ADDENDUM

Issued: 2/1/2022

Addendum No. 01
New City Library Addition and Renovation
VMDO Project No. 1301

REFLECTED CEILING PLAN - LOWER LEVEL & BASEMENT

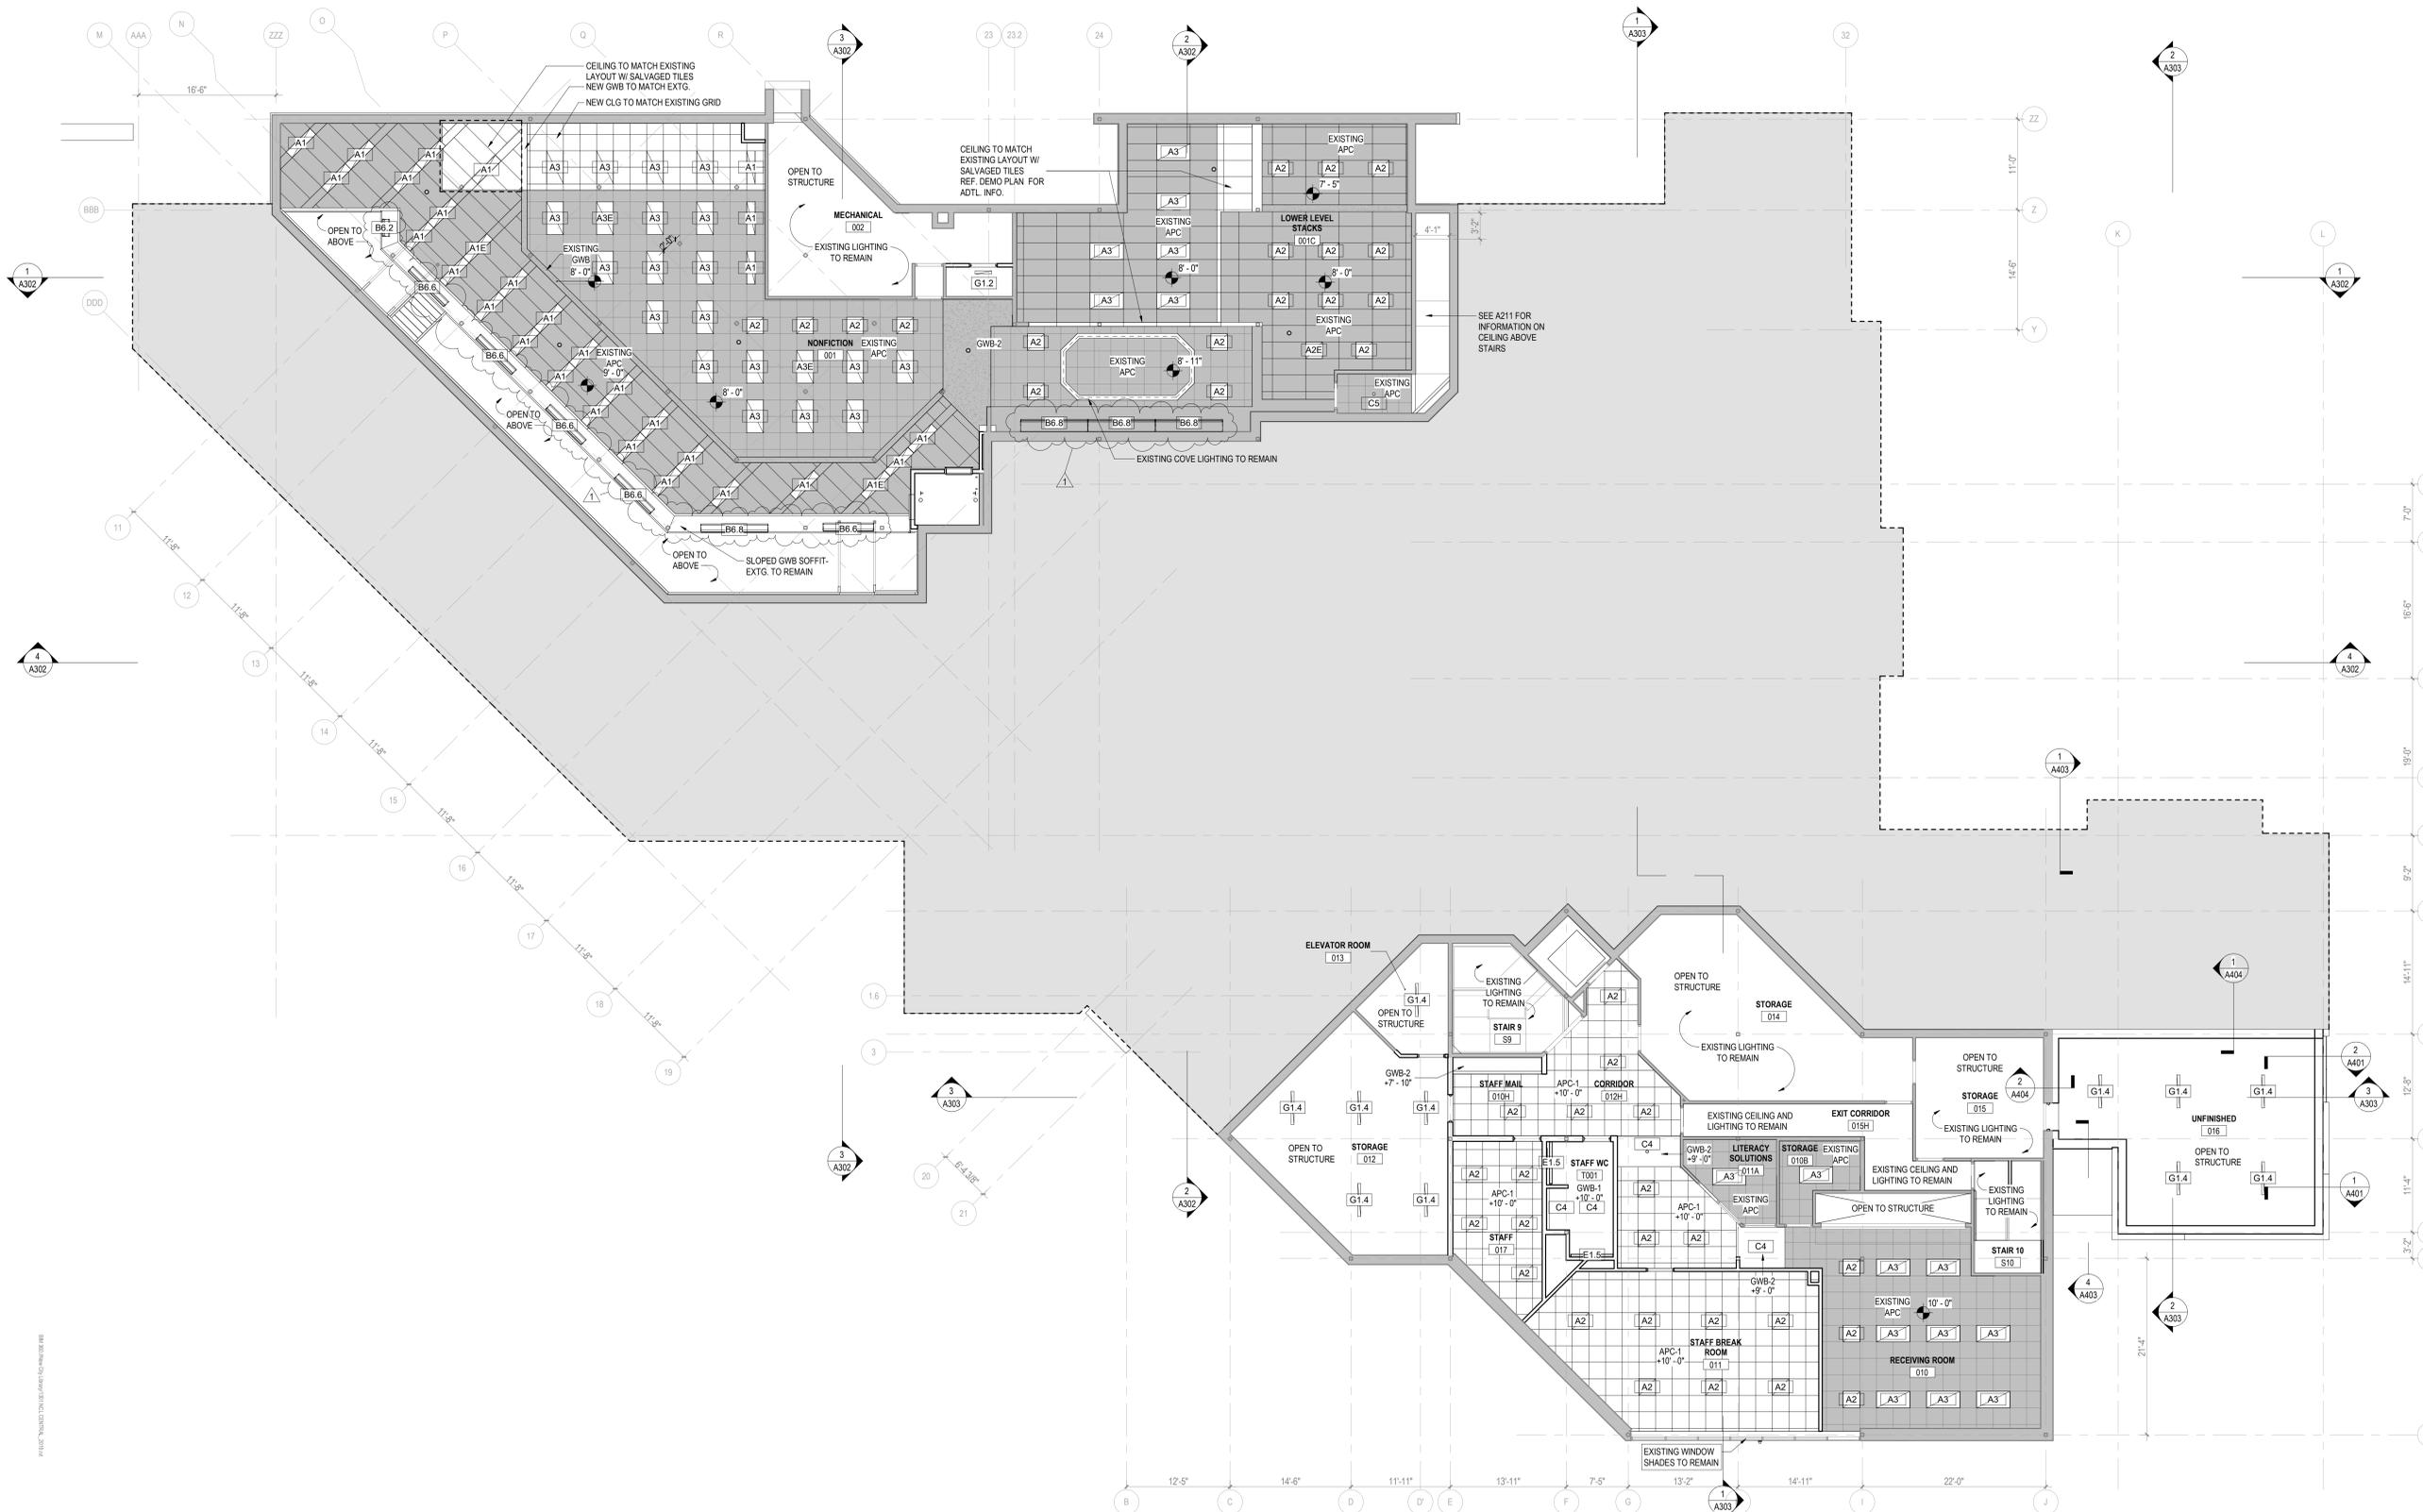
- Addition and deletion of select light fixtures.

2 ELEVATOR SUMP PUMP DETAIL
SCALE: NONE

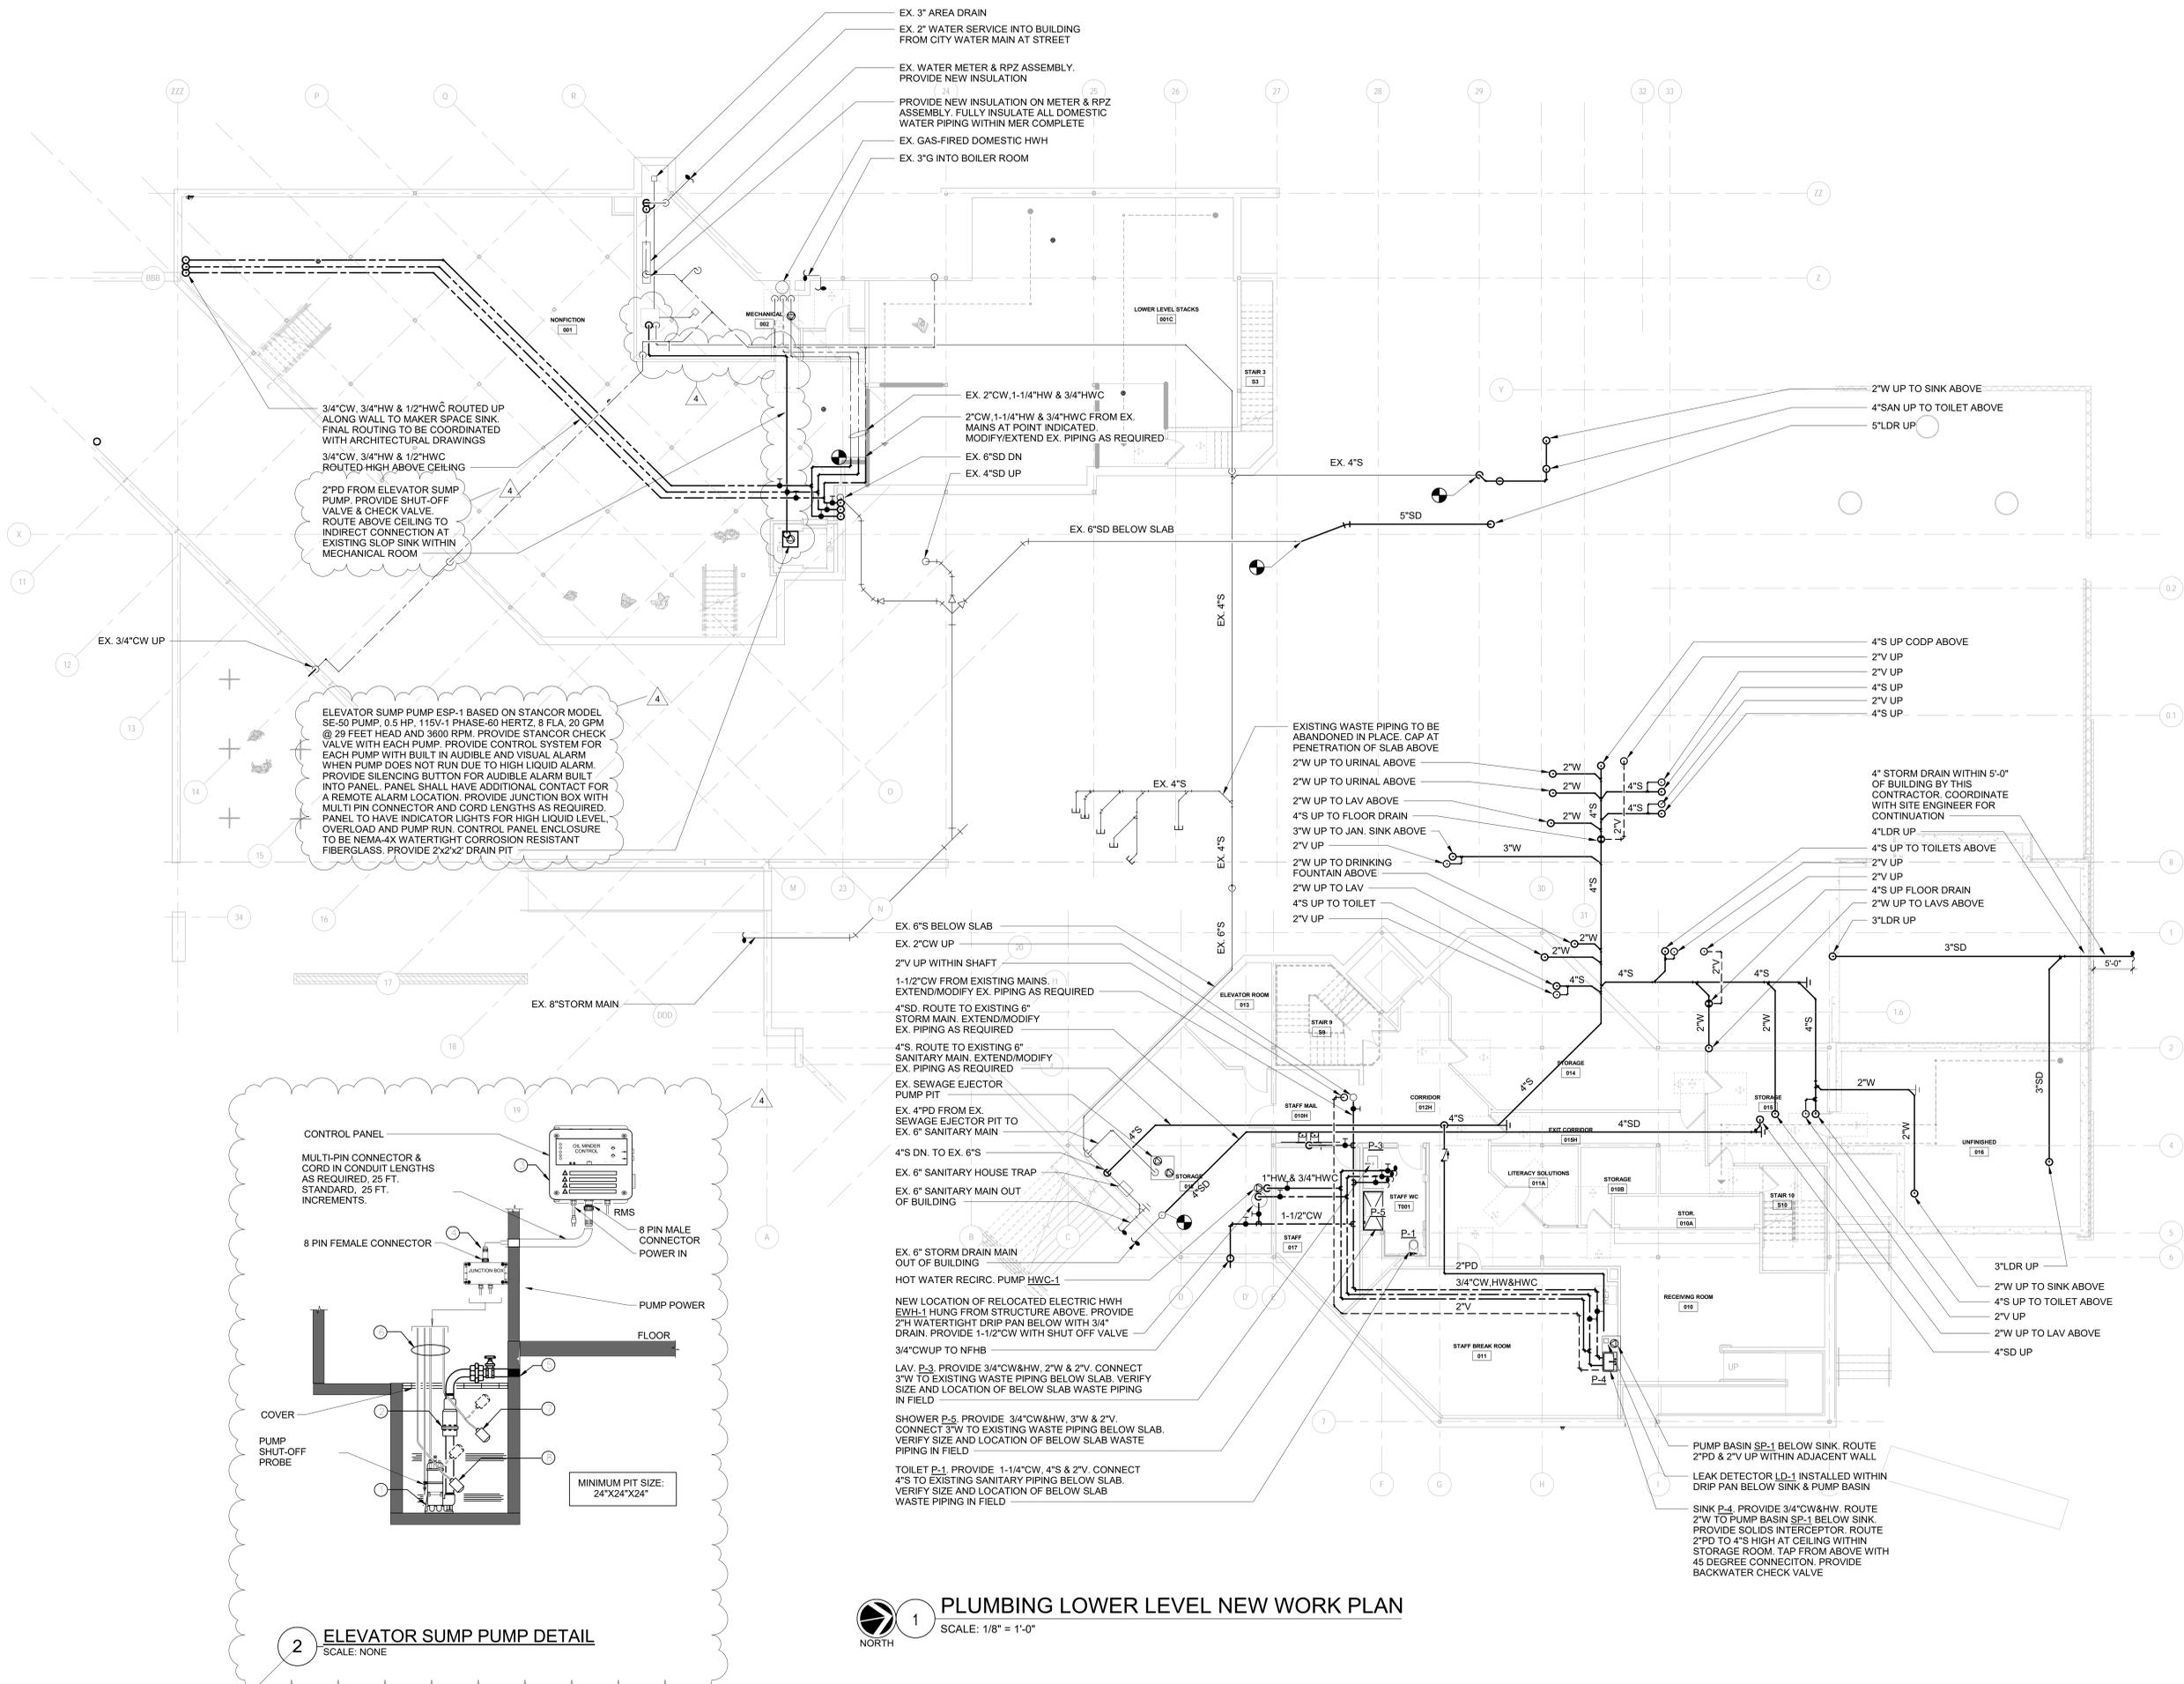
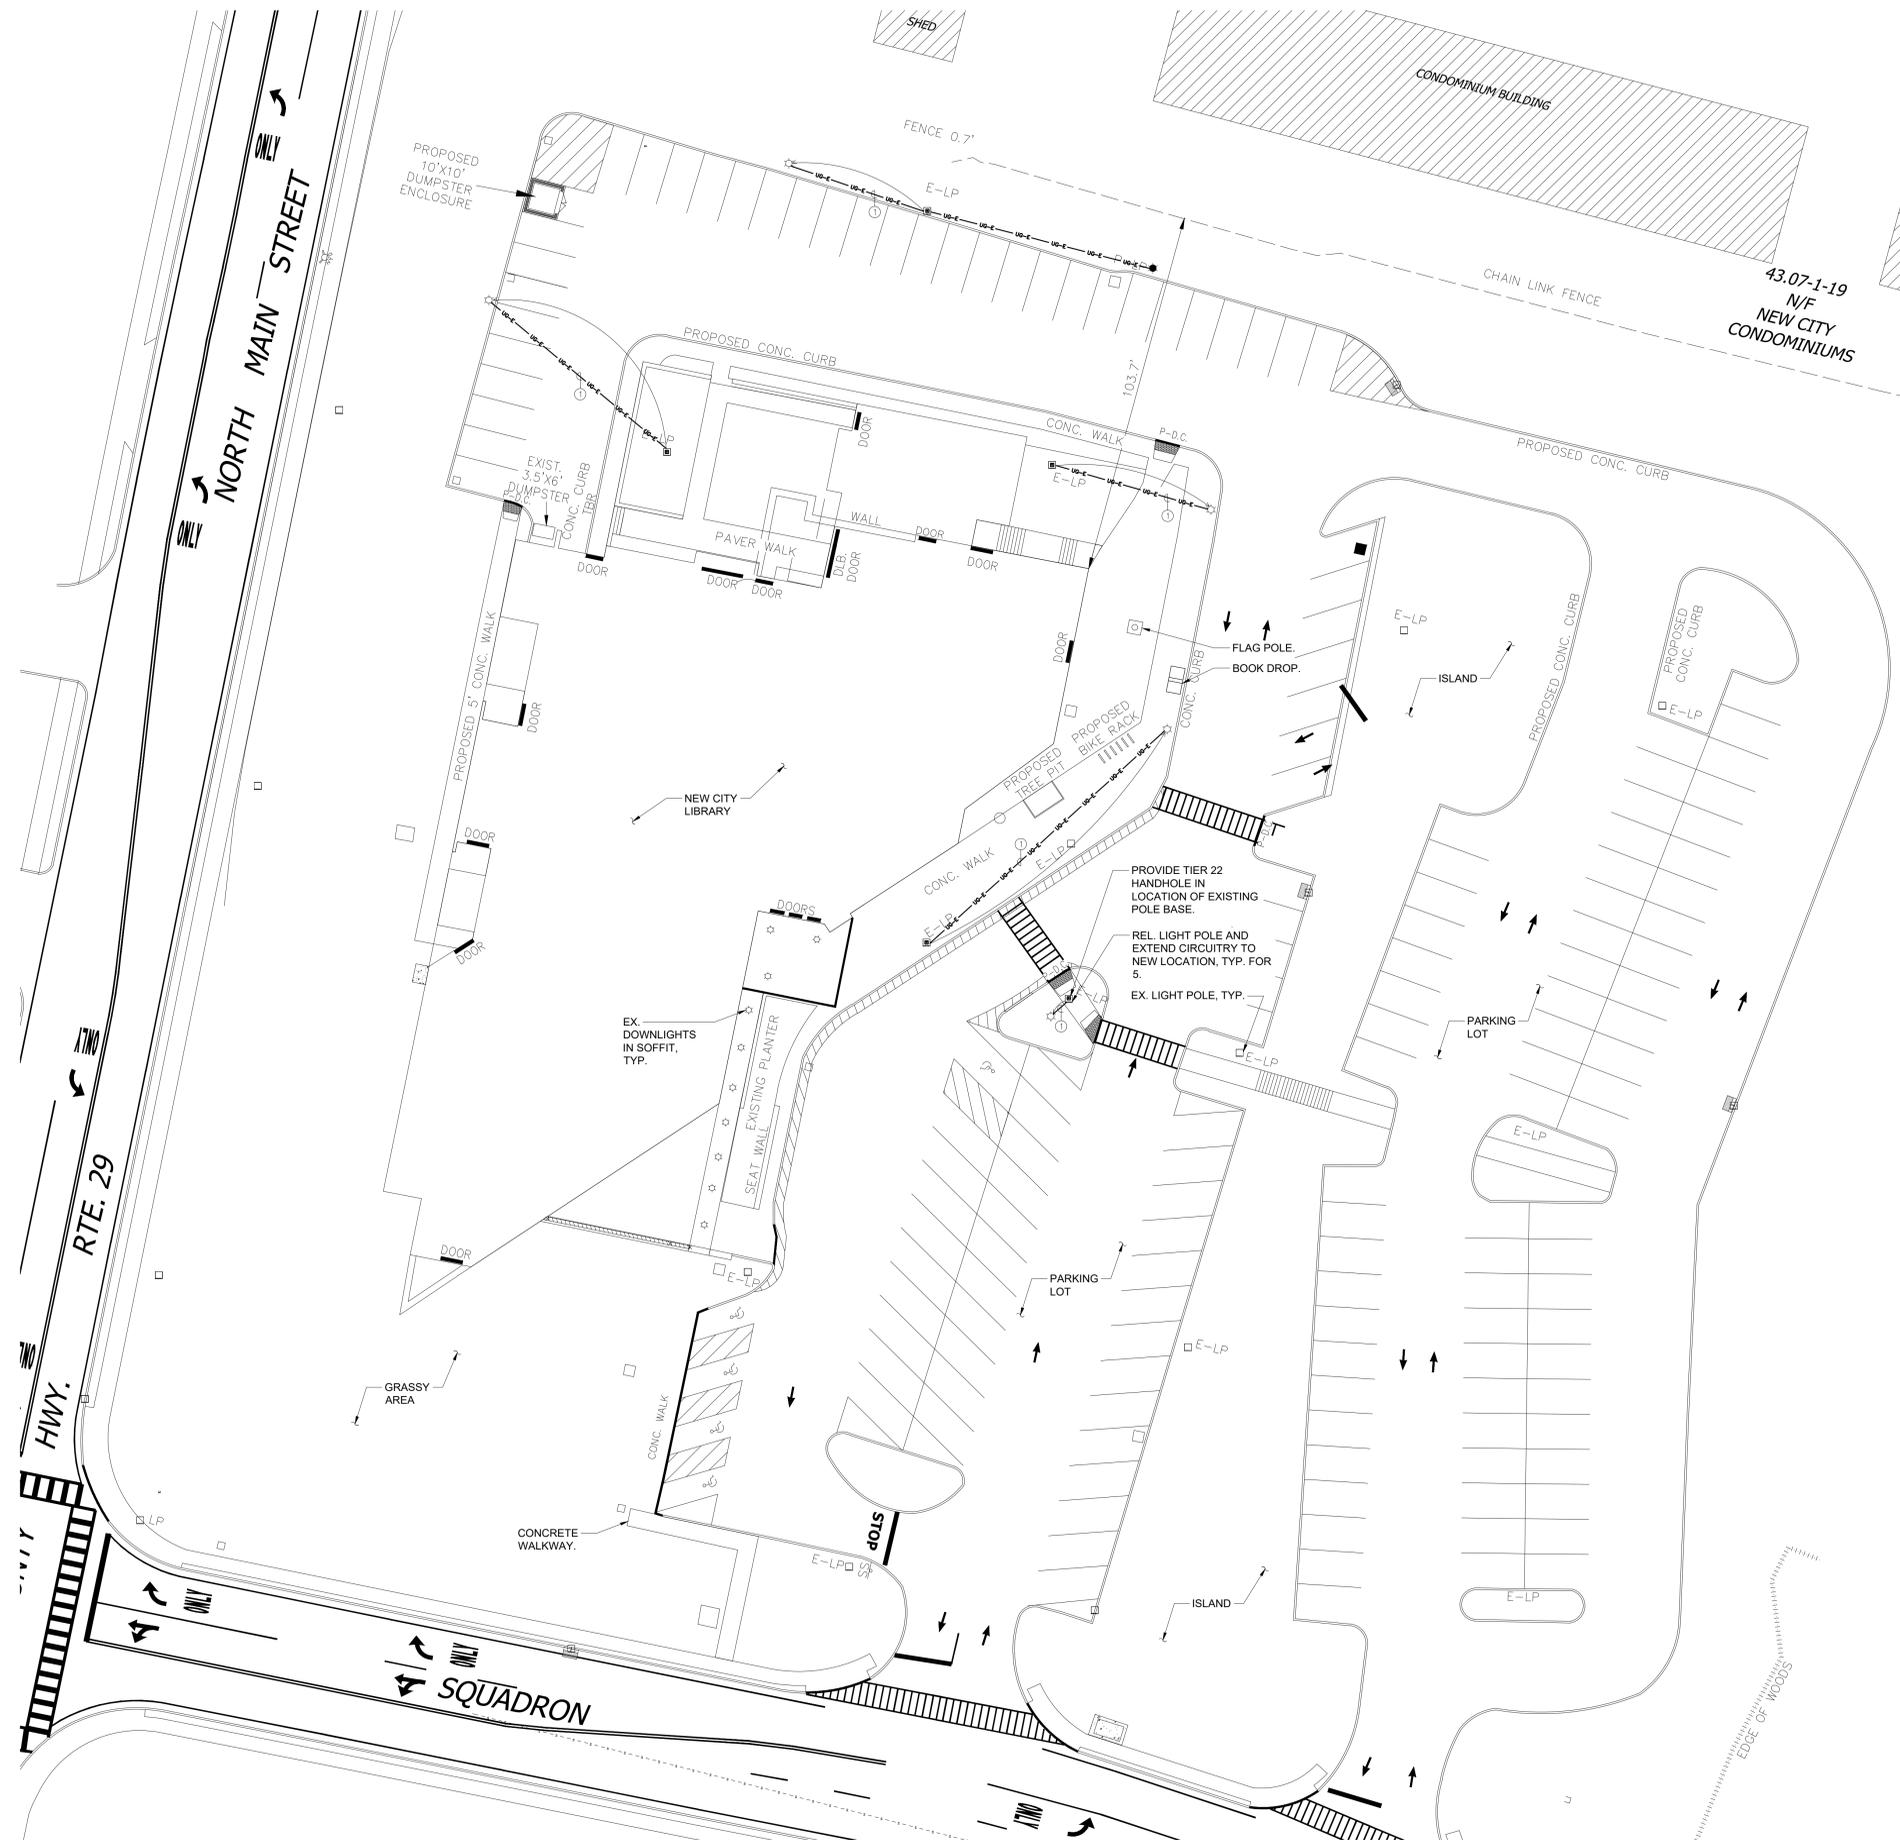
- Addition of elevator sump pump details.
-
